RE – Wellington Solar Farm (SSD-8573) Notice of development footprint modification

As you would be aware, you are a Registered Aboriginal Party (RAP) for the Wellington Solar Farm project that was granted State Significant Development (SSD) planning approval on the 25 May 2018 for the construction and operation of a 174 megawatt (MW) photovoltaic (pv) solar farm and associated infrastructure including access tracks, overhead transmission lines, battery storage facility, substation and transformers. The Wellington Solar Farm will be located about 2 km north-east of Wellington in the Dubbo Regional Local Government Area (LGA).

Figure 1. Proposed modification.

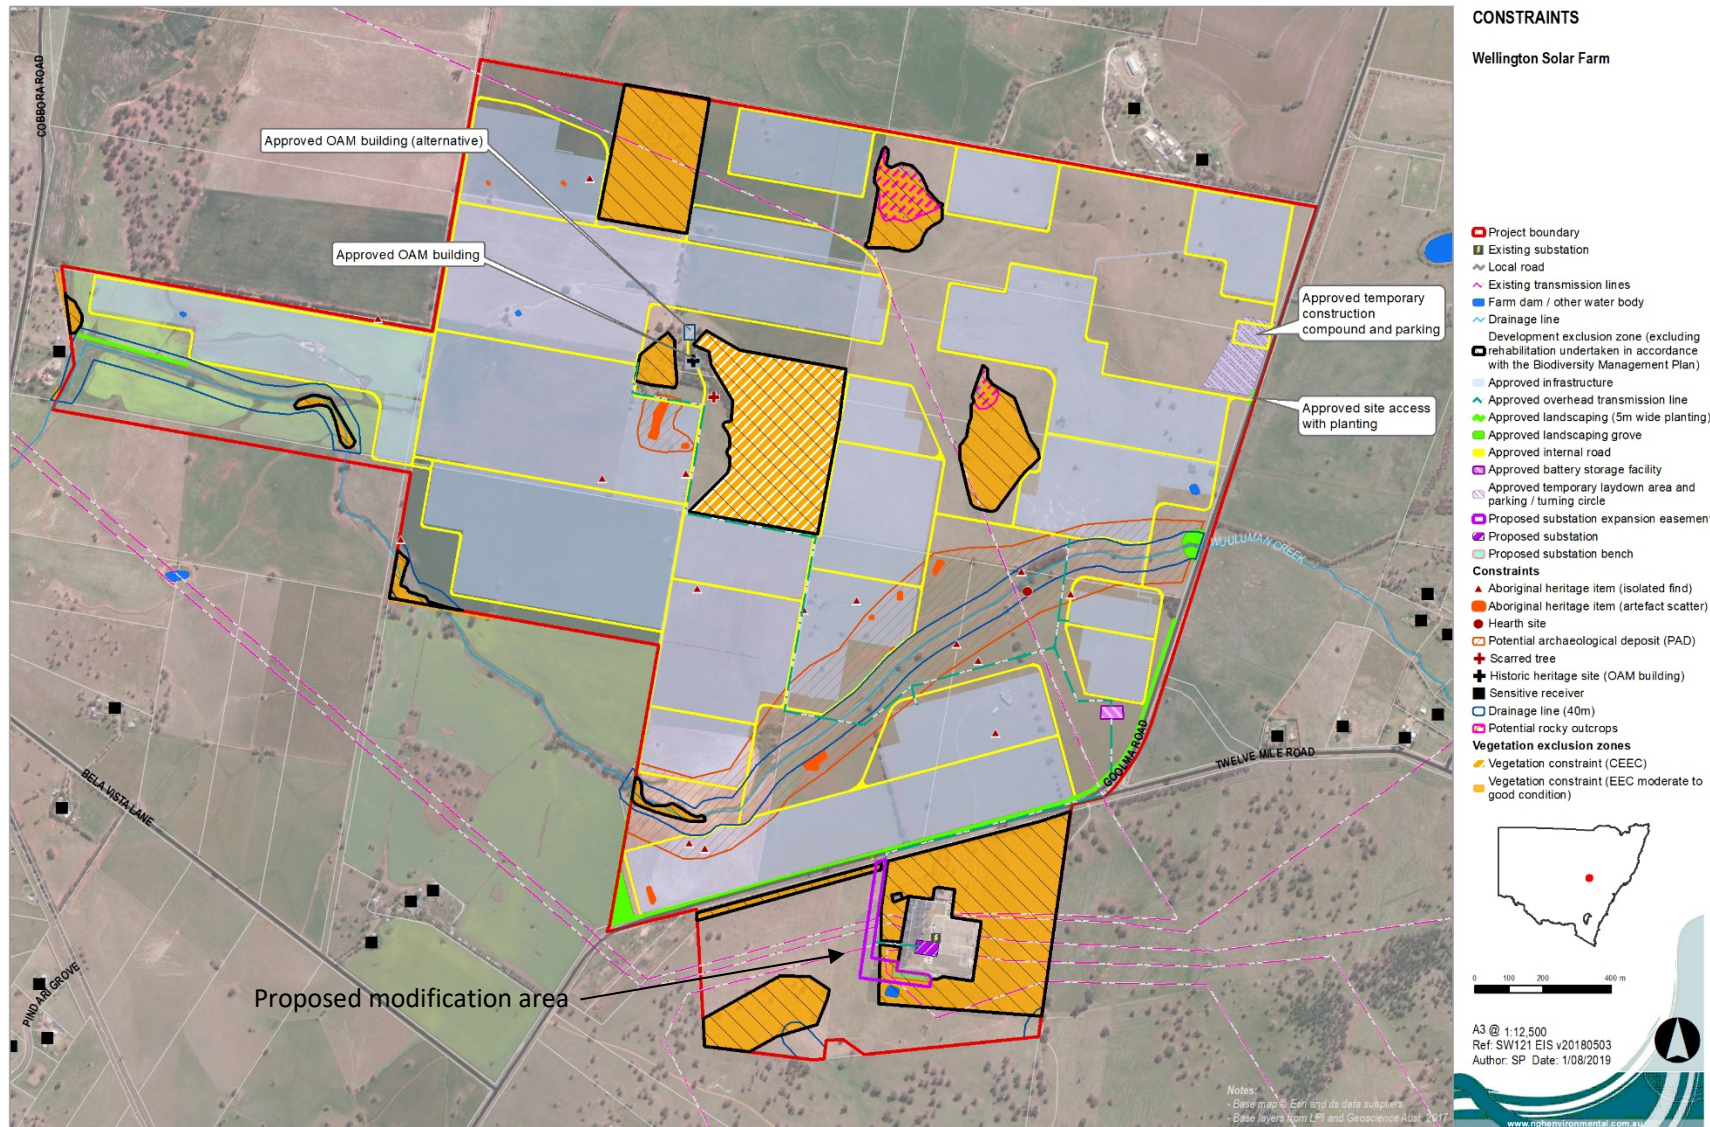
Recently NGH Environmental was informed that a modification to the development footprint is required to connect the solar farm to the existing adjacent substation. The modification will impact approximately 1.8 hectares as shown in Figure 1 with the proposed transmission line roughly following an existing fence line before connecting to the south-western side of the substation.

The desktop assessment, combined with the review of previous field data and results, have concluded that the proposed modification development footprint has previously been adequately assessed by archaeologist with Aboriginal community representatives and does not require further field assessment. No Aboriginal objects/sites or areas of potential archaeological deposit were identified within or adjacent to the proposed modification development footprint.

The desktop review and assessment of the proposed modification concluded that the development footprint will not impact upon previously recorded Aboriginal sites or areas of potential archaeological deposit. The desktop review and assessment noted that the area was deemed during previous investigations of the area to have low archaeological sensitivity and to have been highly disturbed. Therefore, the proposed modification to the development footprint in no way alters or affects the assessment or recommendations in the Wellington Solar Farm Aboriginal Cultural Heritage Assessment Report (NGH 2018) or Cultural Heritage Management Plan (CHMP) that has been developed for the project.
